**Comanche Peak Nuclear Power Plant, Units 3 & 4  
COL Application  
Part 2, FSAR**

**2.4.3 Probable Maximum Flood**

CP COL 2.4(1) ~~Replace the content~~Add the following at the end of DCD Subsection 2.4.3 ~~with the following.~~ | RCOL2\_02.0  
4-1

Figure 2.4.3-203 Squaw Creek Probable Maximum Precipitation Hyetograph

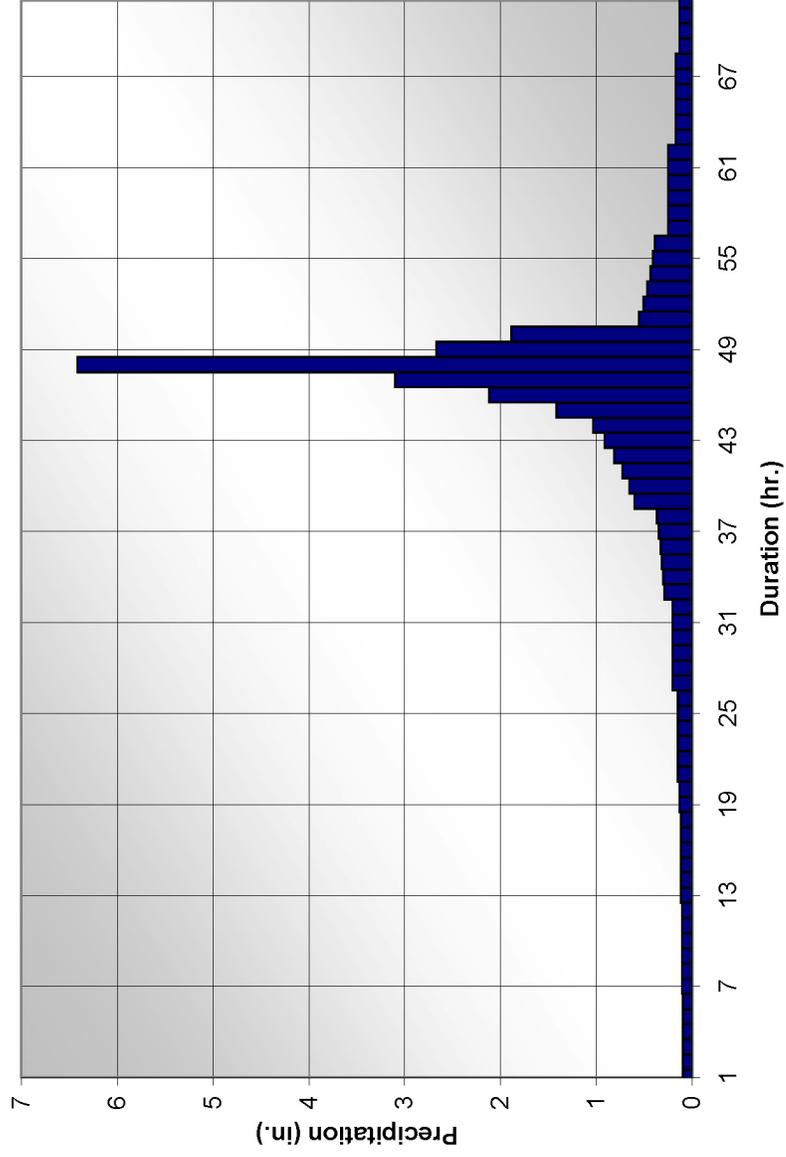
The critical 72-hr storm PMP rainfall total is 38.46 in for the Squaw Creek watershed. The standard HMR 52 temporal arrangement of 6-hr precipitation increments is provided in **Table 2.4.3-202**. The critical temporal distribution was determined by runoff analysis to be an two-thirds peaking arrangement for the Squaw Creek watershed. The hourly end temporal distribution of the 72-hr PMP rainfall for **each of the 4 subbasins** Basin 2 is provided in **Table 2.4.3-203**. The corresponding hyetograph is shown in **Figure 2.4.3-203**.

Figure 2.4.3-204 Paluxy River Probable Maximum Precipitation Hyetograph

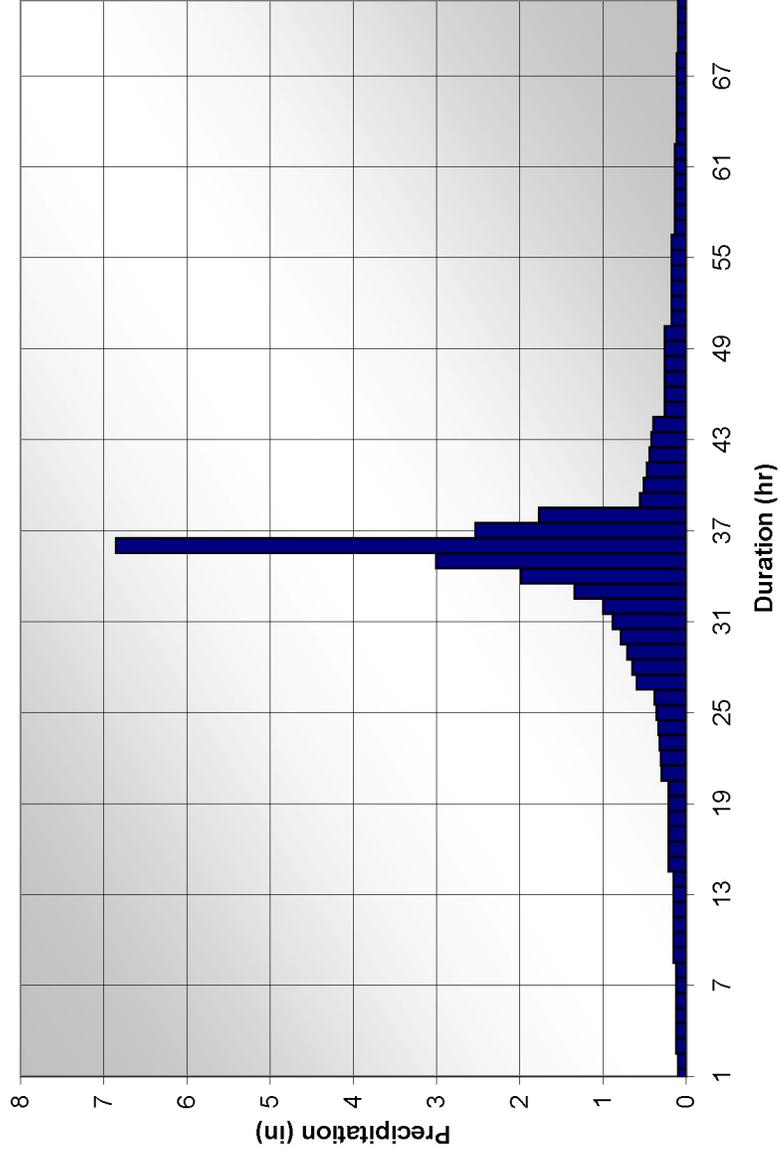
The critical 72-hr storm PMP rainfall total is 35.08 in for the Paluxy River watershed. The standard HMR 52 temporal arrangement of 6-hr precipitation increments is provided in [Table 2.4.3-204](#). The critical temporal distribution was determined by runoff analysis to be a ~~one-third~~center peaking arrangement for the Paluxy River watershed. The hourly temporal distributions of the 72-hr PMP rainfall for ~~each of the 4 subbasins is~~Basins 3 and 4 are provided in [Table 2.4.3-205](#). The corresponding hyetographs ~~are is~~ shown in [Figure 2.4.3-204 and 2.4.3-212](#).

Figure 2.4.3-206 SCR Storage Elevation Discharge Rating Curve

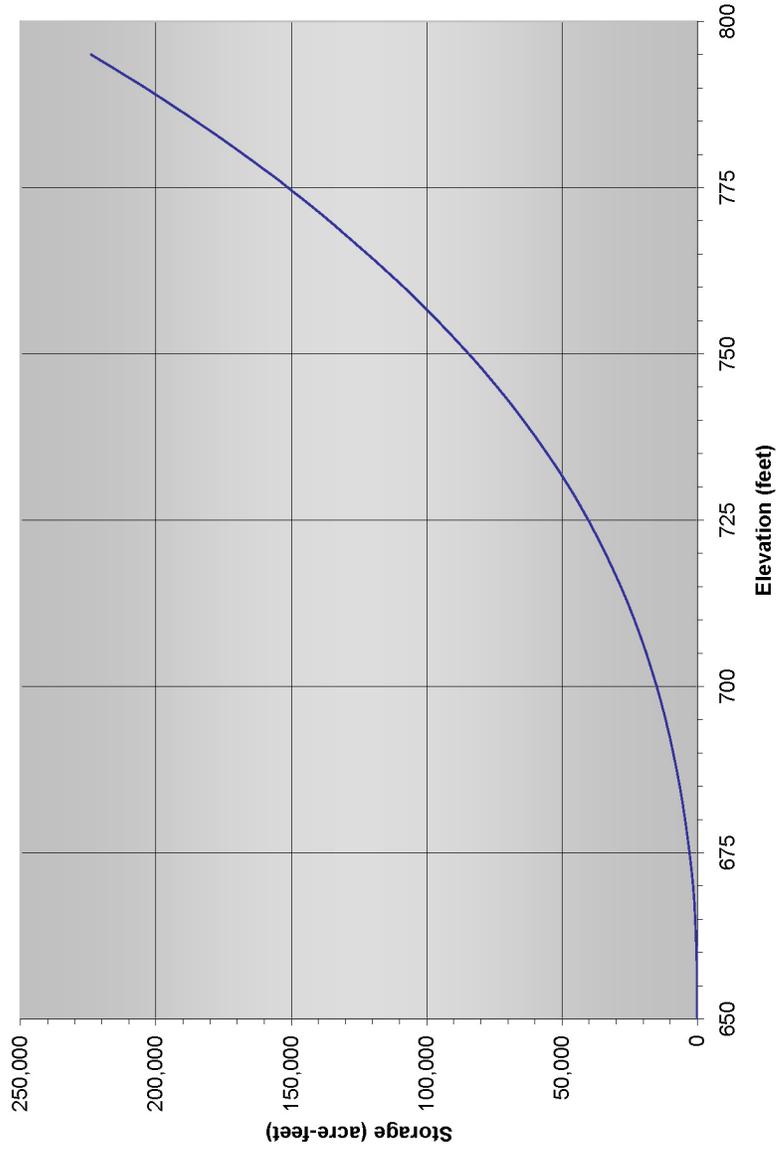
SCR is the only significant reservoir within the Paluxy River and Squaw Creek watersheds. The storage-elevation ~~for the SCR was obtained from~~ rating curve for the SCR is provided in Figure 2.4.3-206 and was obtained from the following two sources:

- The storage-elevation data for elevation 775 ft msl and below have been obtained from ~~1997~~ the TWDB Volumetric Survey for SCR conducted in 2007. (Reference 2.4-212)
- The storage-elevation data for elevations above 775 ft msl have been obtained from ~~and~~ the Operation and Maintenance Procedures for Squaw Creek Dam prepared by Freese and Nichols in 1997.

~~relationship was linearly extrapolated to account for discharge from elevation 791 ft msl to 795 ft. msl. The reservoir rating curve is presented in Figure 2.4.3-206.~~

Figure 2.4.3-208 SCR Probable Maximum Flood Elevation Outflow Hydrograph

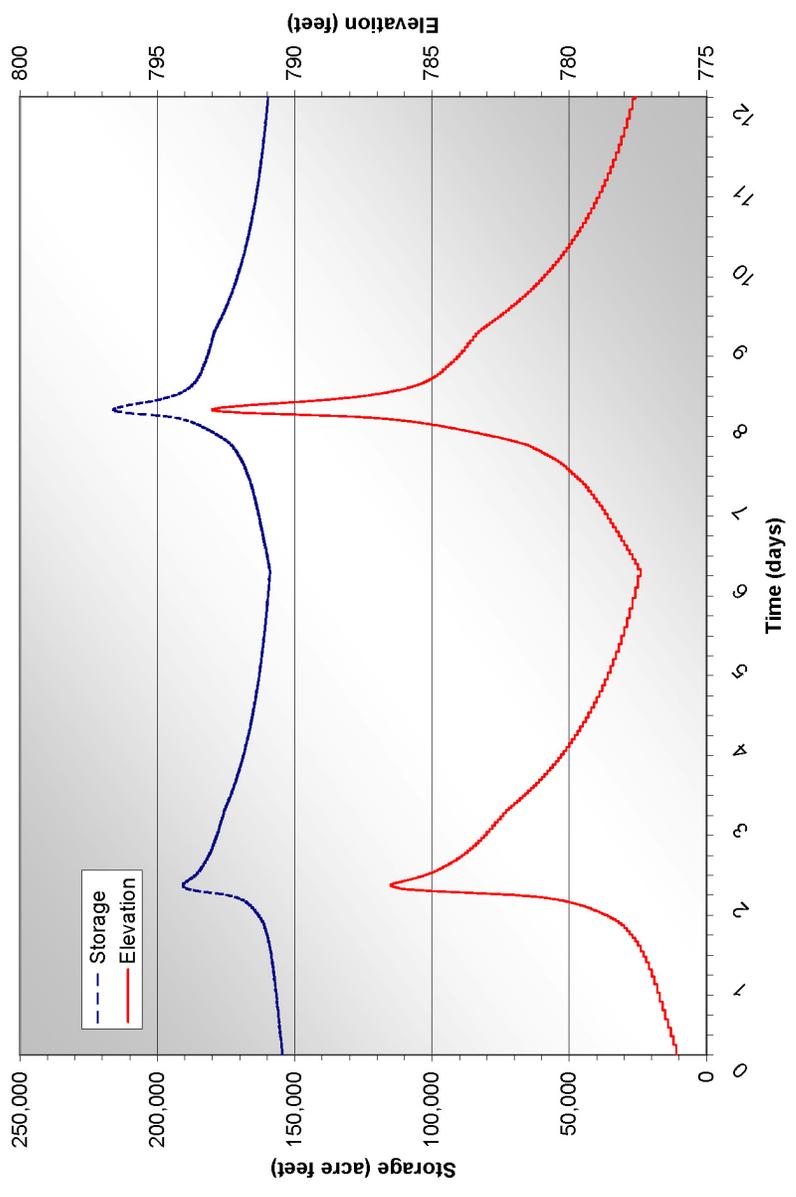
The PMF runoff, routed through the SCR, results in a peak water surface elevation of ~~790.9~~793.0 ft msl at CPNPP Units 3 and 4. The water surface elevation is determined using the HEC-HMS runoff and routing model as described in [Subsection 2.4.3.3](#). The hydrograph for the SCR is provided in [Figure 2.4.3-208](#).

Figure 2.4.3-209 Coincident Wind Wave Activity Fetch Length

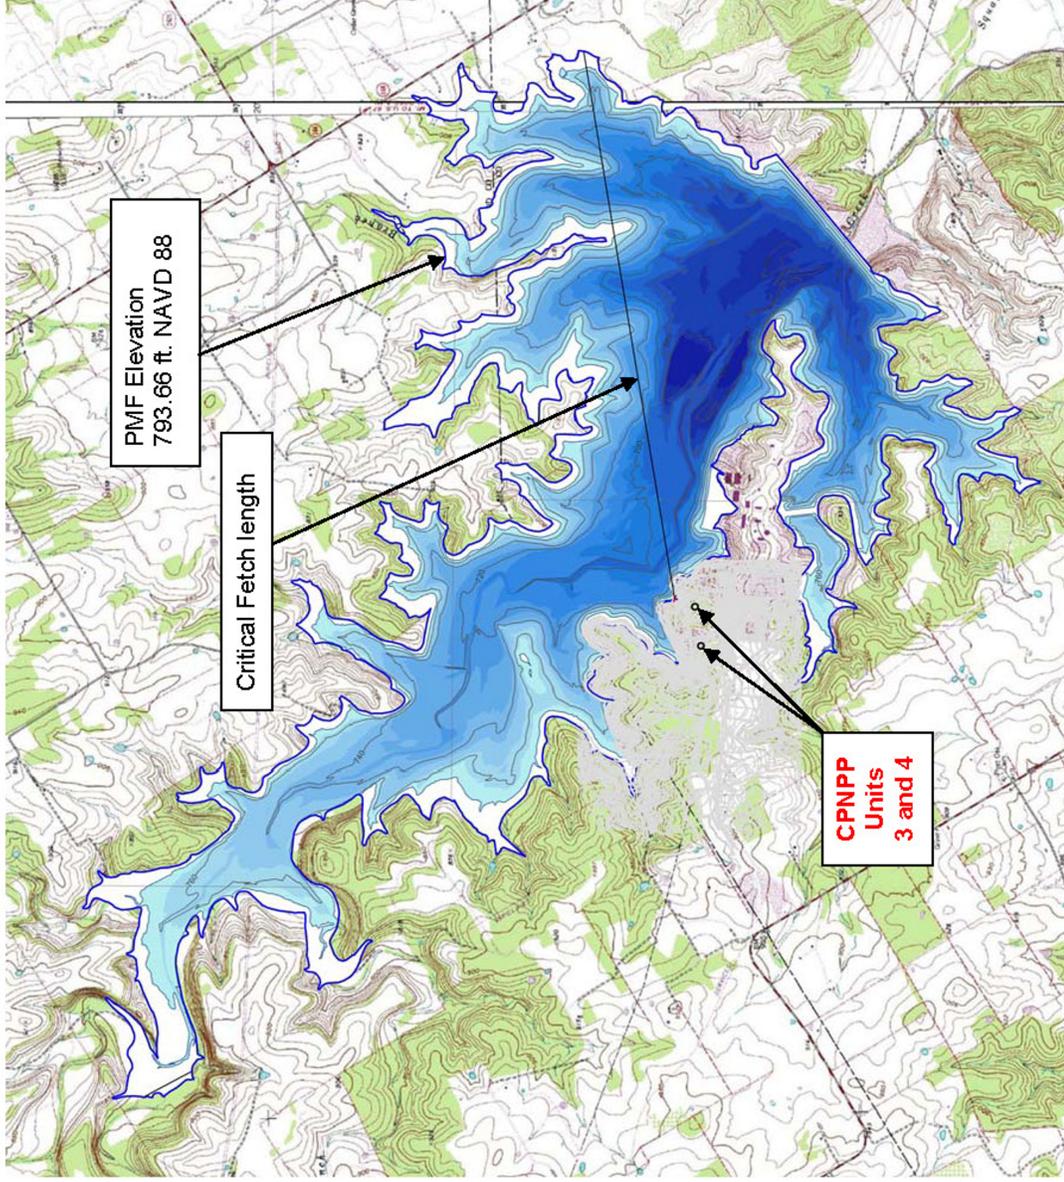
Fetch length was estimated based on USGS Quadrangles and the PMF maximum water surface elevation of SCR. The critical fetch length was found to be ~~2.67~~2.7 mi originating from the east ~~for Fetch 3~~ as shown in **Figure 2.4.3-209**. CPNPP is protected from wind wave activity from the west and south by the local topography. Wave height, setup, and runup are estimated using USACE "Coastal Engineering Manual, EM 1110-2-1100" guidance (**Reference 2.4-235**).

Figure 2.4.3-211 Squaw Creek Reservoir Basin 1 Probable Maximum Precipitation Hyetograph

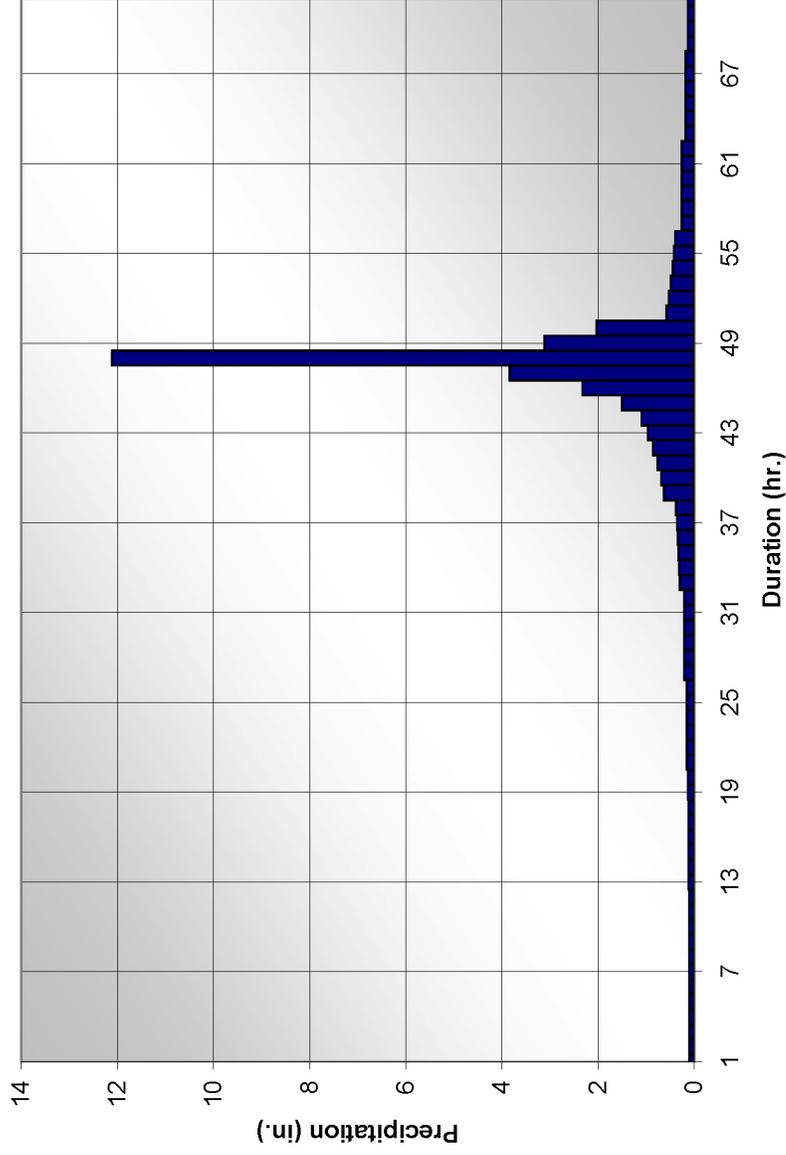
The critical 72-hr storm PMP rainfall total is 42.53 in for the SCR watershed. The standard HMR 52 temporal arrangement of 6-hr precipitation increments is provided in Table 2.4.3-208. The critical temporal distribution was determined by the runoff analyses to be a two-thirds peaking arrangement for the SCR watershed. The hourly temporal distribution of the 72-hr PMP rainfall for the SCR watershed, Basin 1, is provided in Table 2.4.3-209. The corresponding hyetograph is shown in Figure 2.4.3-211.

Figure 2.4.3-213 Snyder's Unit Hydrograph Basins 1a and 1c

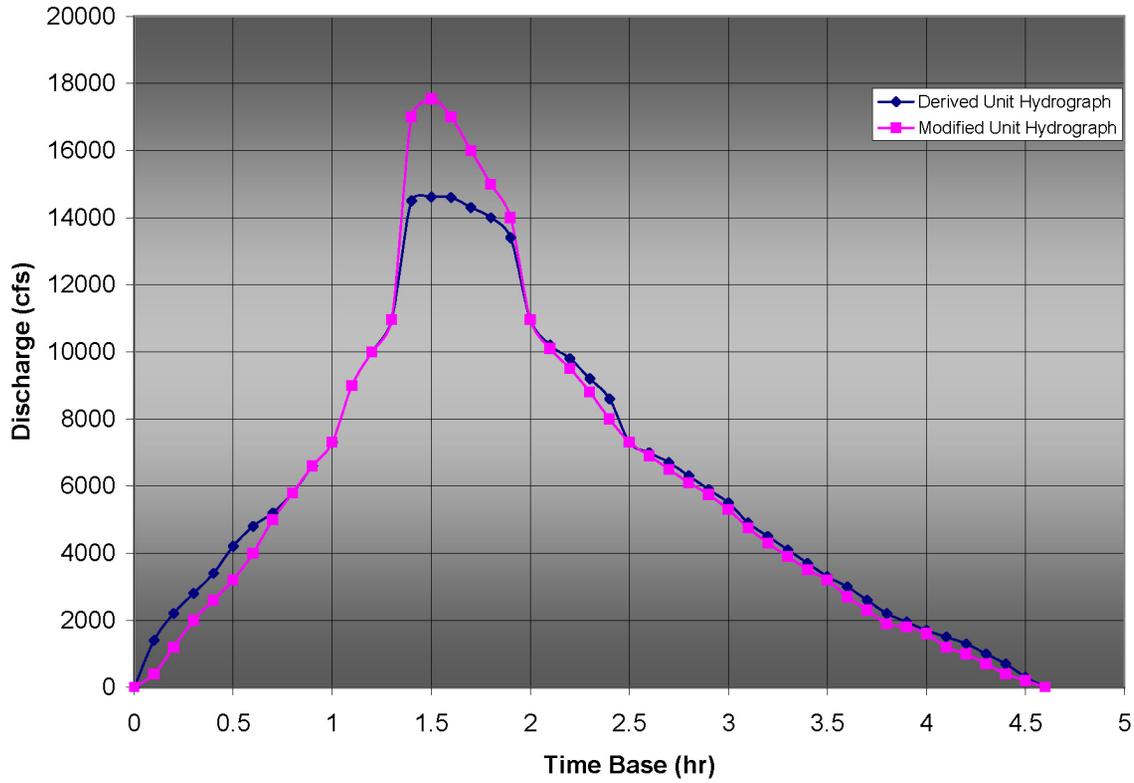
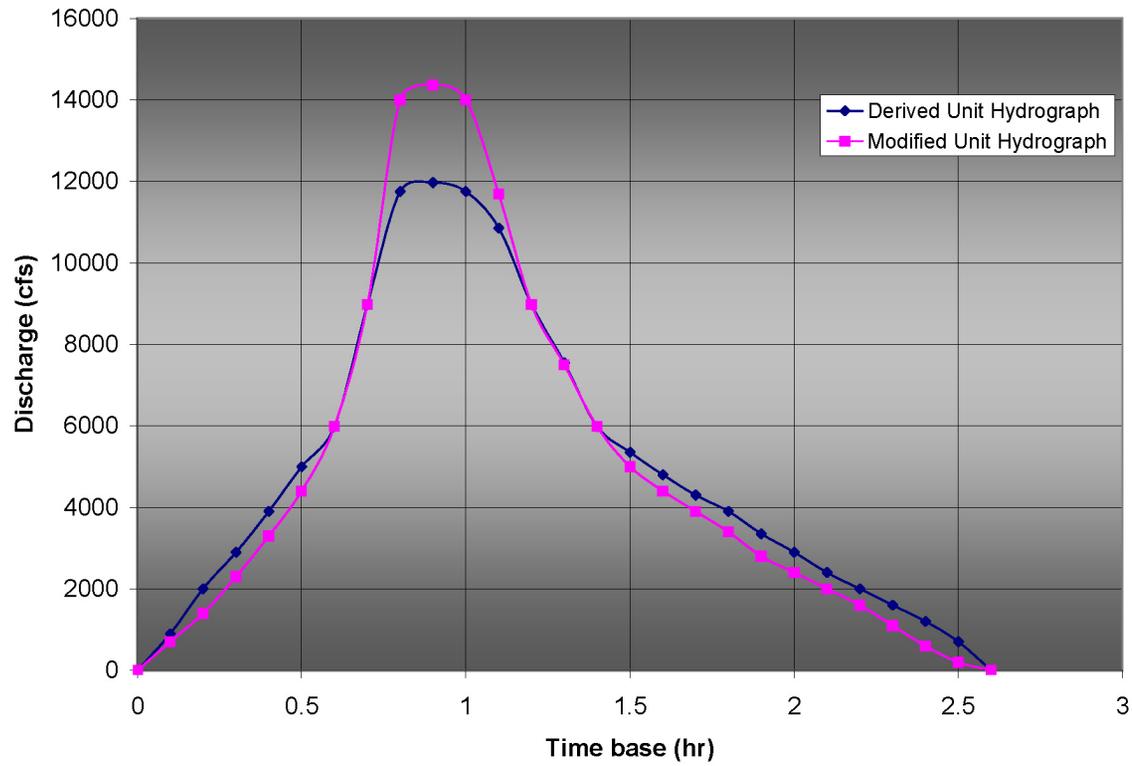
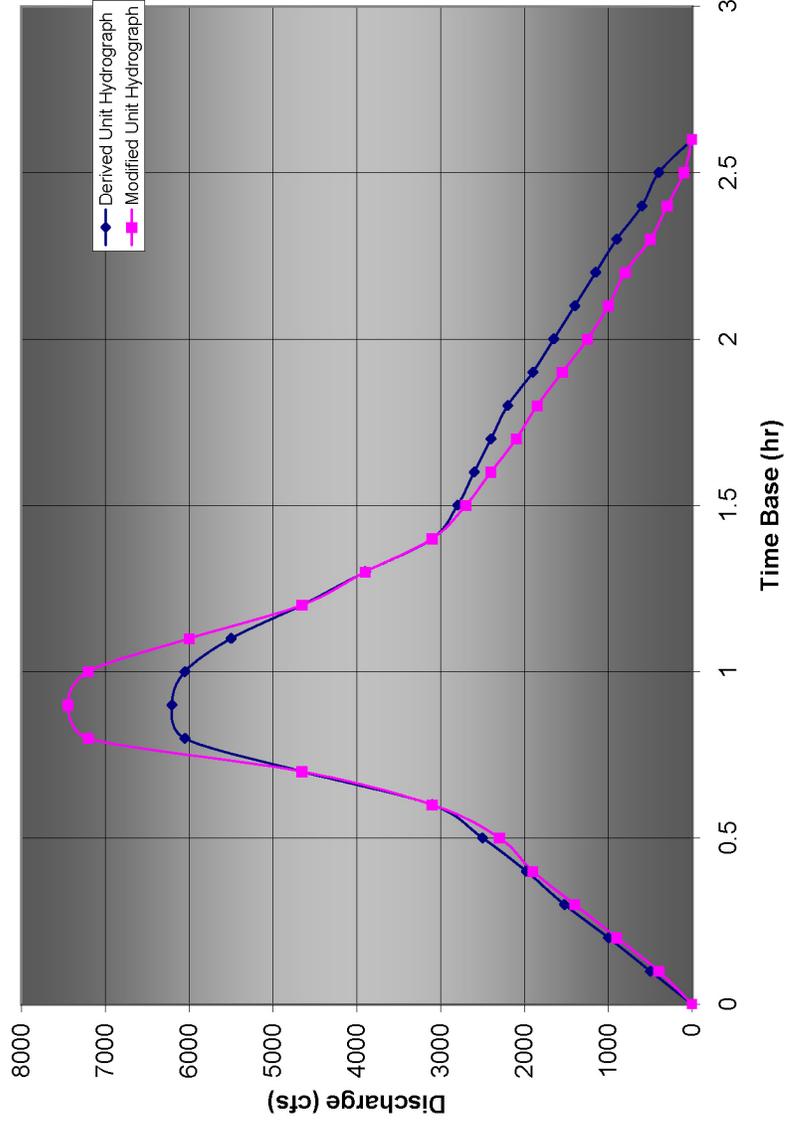
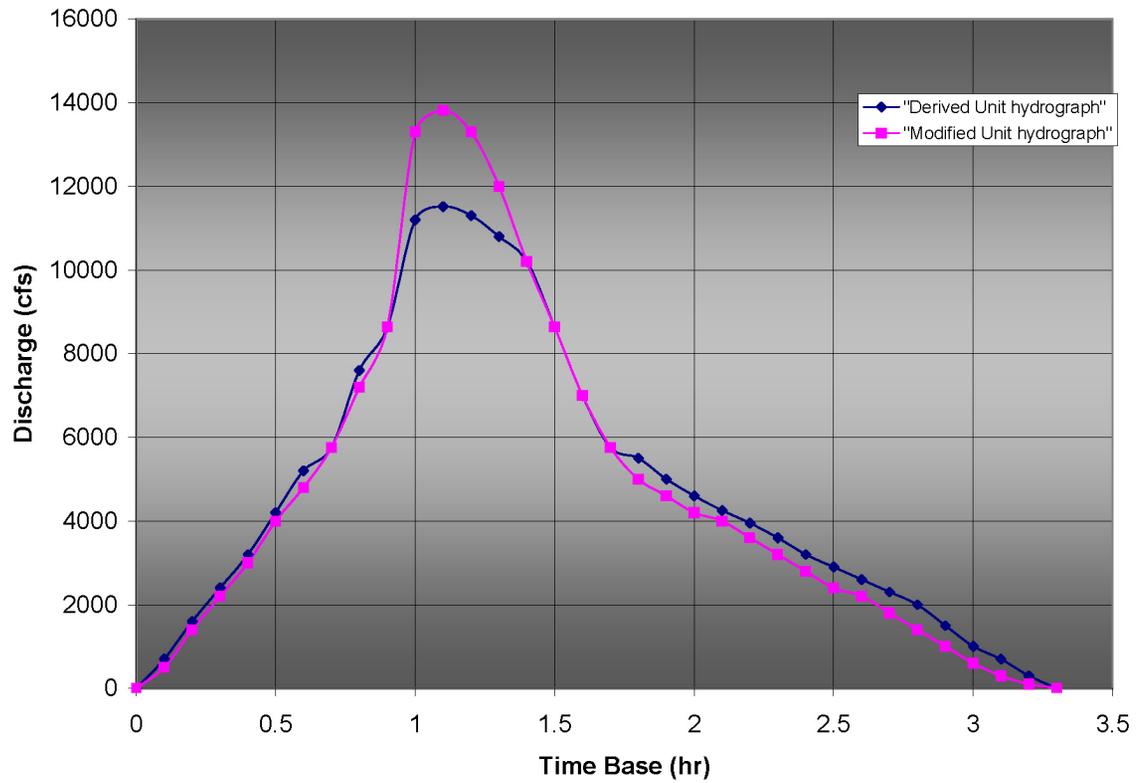
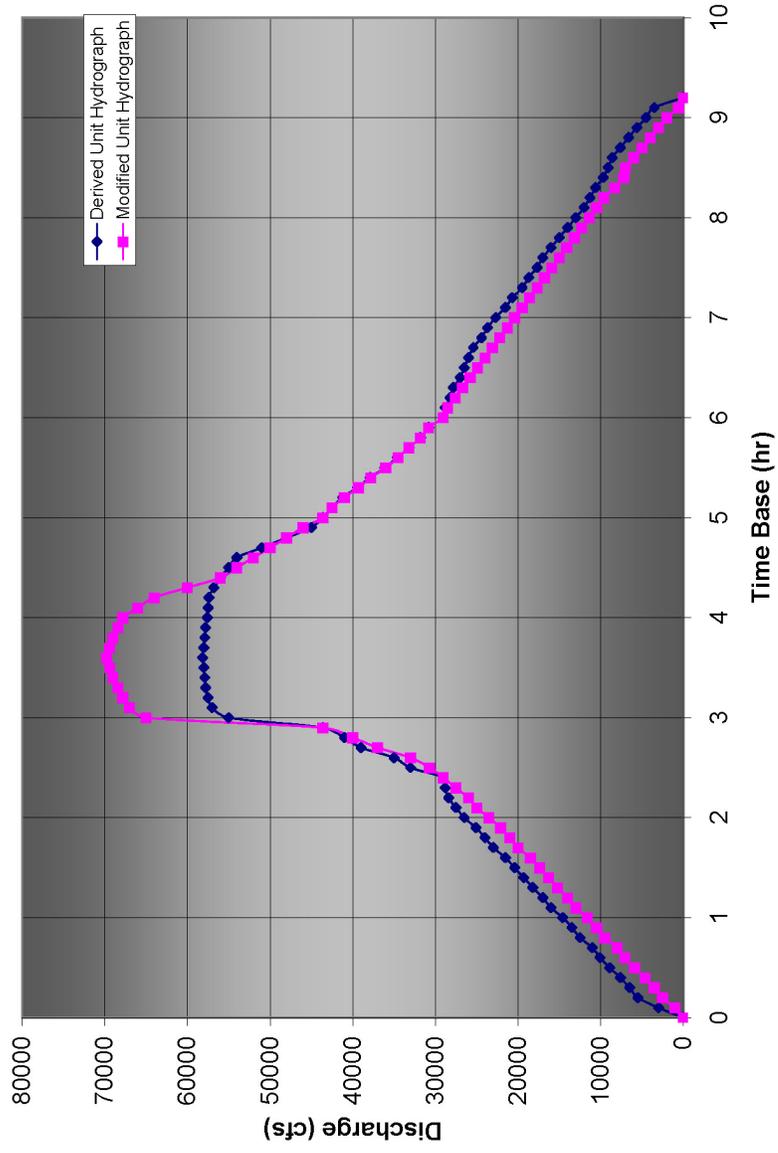
Using the watershed subbasin characteristics provided in Table 2.4.3-207, the Snyder's unit hydrograph method was applied to derive unit hydrographs for each subbasin. The resulting Snyder's unit hydrograph characteristics and equations utilized are provided in Table 2.4.3-210. To account for nonlinear basin response at high rainfall rates, the peak of the unit hydrograph for each subbasin has been increased by 20 percent. The unit hydrograph was then adjusted to maintain the unit hydrograph characteristic of 1 in of runoff. The derived and modified to account for nonlinear basin response unit hydrographs are provided for each subbasin. The Basin 1a and 1c unit hydrographs are shown in Figure 2.4.3-213. The Basin 1b unit hydrographs are shown in Figure 2.4.3-214. The Basin 2 unit hydrographs are shown in Figure 2.4.3-215. The Basin 3 unit hydrographs are shown in Figure 2.4.3-216. The Basin 4 unit hydrographs are shown in Figure 2.4.3-217.
